**TOWN OF HERNDON, VIRGINIA
ARCHITECTURAL REVIEW BOARD
PUBLIC HEARING AGENDA
FEBRUARY 19, 2020
HERNDON COUNCIL CHAMBERS BUILDING
765 LYNN STREET
7:30 P.M.**

8. **APPLICATION FOR A WALL OR WINDOW SIGN, ARB #20-005**, to consider an application to install two new tenant business wall signs on the multi-tenant commercial building located at 311 Spring Street, Herndon, Virginia, located between the intersection of Spring Street and Van Buren Street and the intersection of Spring Street and Herndon Parkway, and further identified as Fairfax County Tax Map 0162-02-0174D. The property is zoned PD-B, Planned Development - Business, and consists of 168,916 square feet of land. Owner/Applicant: Herndon-Reston Industrial LLC c/o Kenwood Management Company. Applicant's Representative: Heather Davis, Gable Company.

Subject: February 2020 ARB Case Update, ARB #20-005, 311 Spring Street

1 ELEVATION DETAIL - TOTAL SF = 14.04
SCALE: 3/4" = 1'

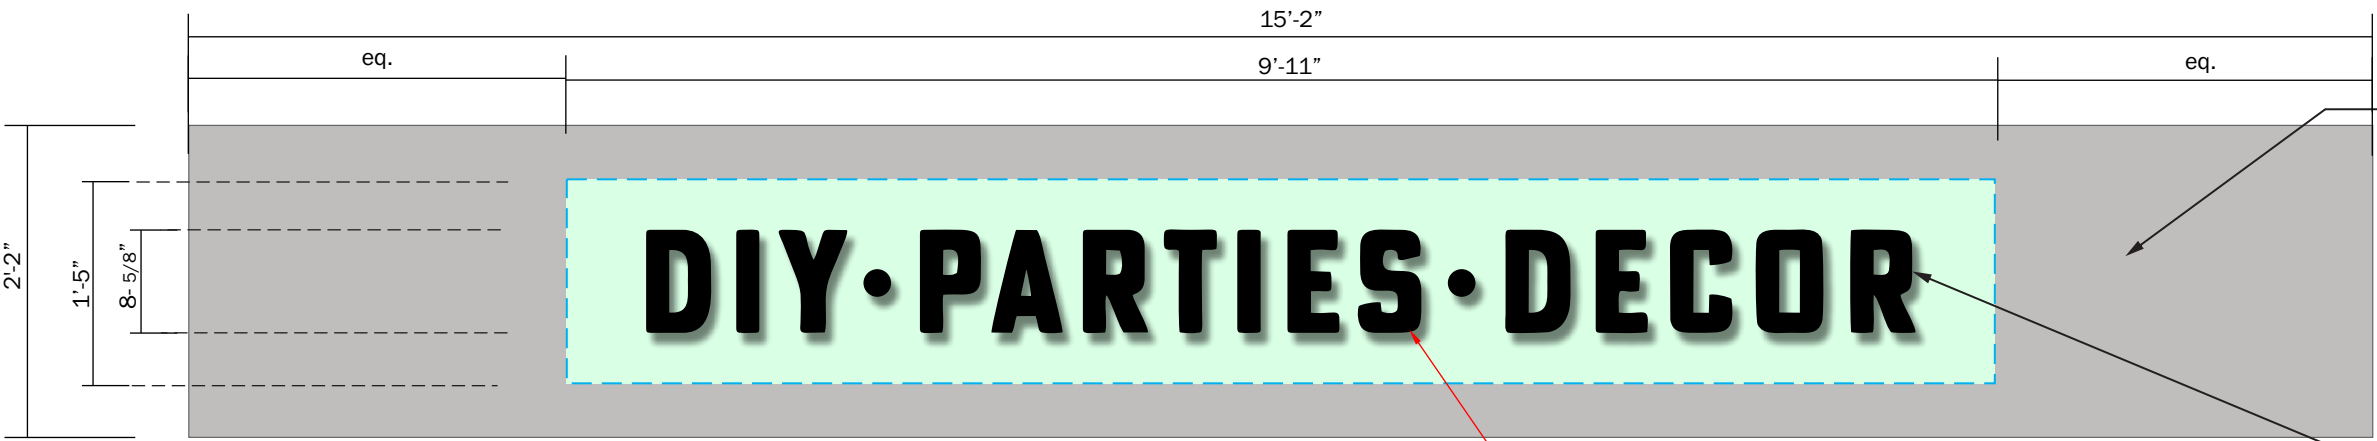
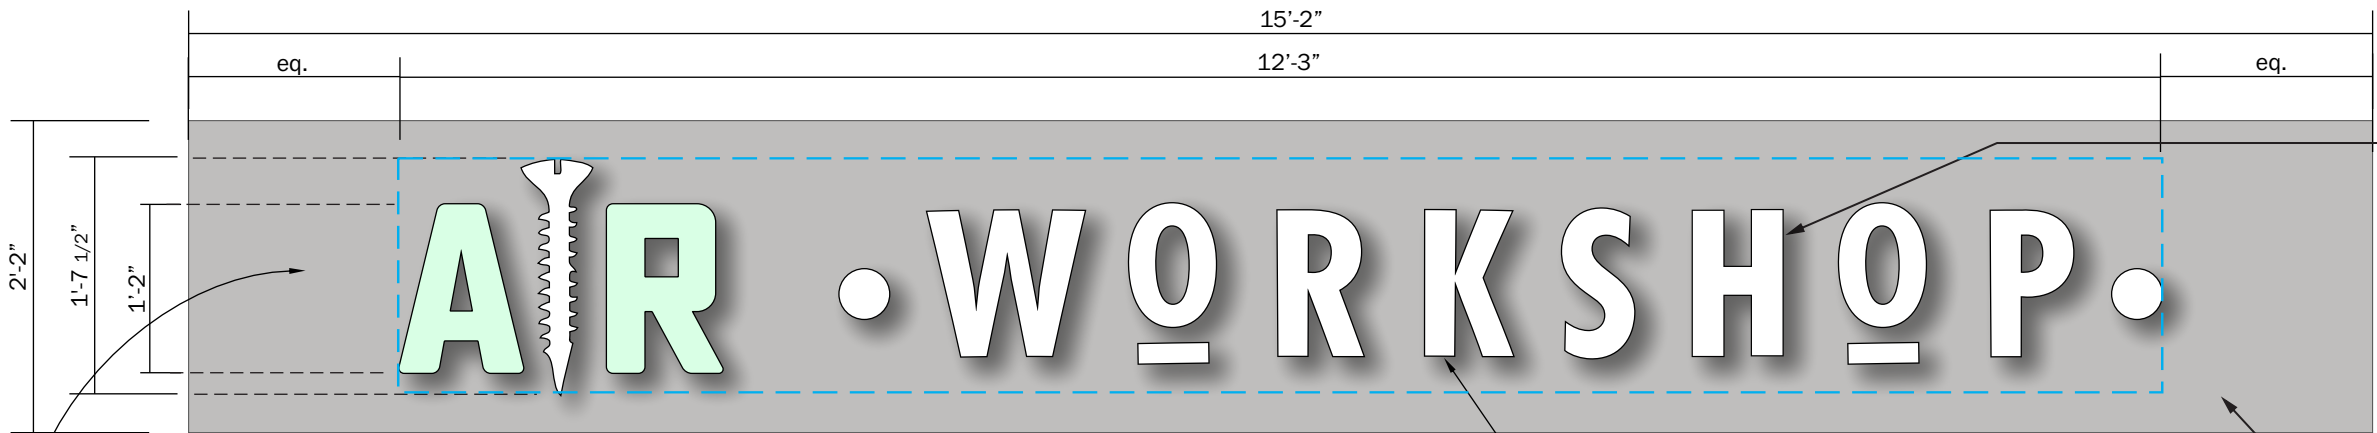
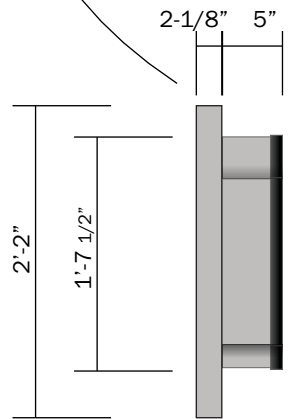
Since the February 5, 2020 ARB Work Session, staff has received updated printed and electronic submission materials from the applicant that shows that the grey material presenting in the previous paper submission was, in fact, a printing error and the intended design was accurately represented in the staff Power Point presentation. However, the applicant is still showing the *DIY-PARTIES-DECOR* sign to be off center on the existing sign panel on the end tenant space on the northwest corner of the elevation, with the applicant continuing to state that the northeast corner tenant space is also off-center as shown in the Elevation View – Spring Street rendered elevation on Sheet A-100 of the applicant's most recent submission. After further field documentation, staff has found that the existing sign on the northeast corner is not off center (as shown in the applicant's rendering) but is actually centered on the sign panel and congruent in placement of the other existing signs approved by the ARB (see Exhibits 1 and 2). Staff believes that this horizontal and vertical centering of signs on each of the deliberately designed sign panels is the original design intent and should be continued.

- 1) Applicant shall revise all submission materials to reflect the horizontal and vertical centering of the *DIY-PARTIES-DECOR* sign on the sign panel to be congruent to the remaining signs on the north elevation;**
- 2) Revised design materials meeting Condition #1 shall be submitted to staff prior to issuance of a building permit; and**
- 3) Proposed signs shall be constructed and installed in substantial conformance with the original design materials submitted with the original application, the revised application materials submitted on February 10, 2020, and any revised design materials meeting Condition #1.**
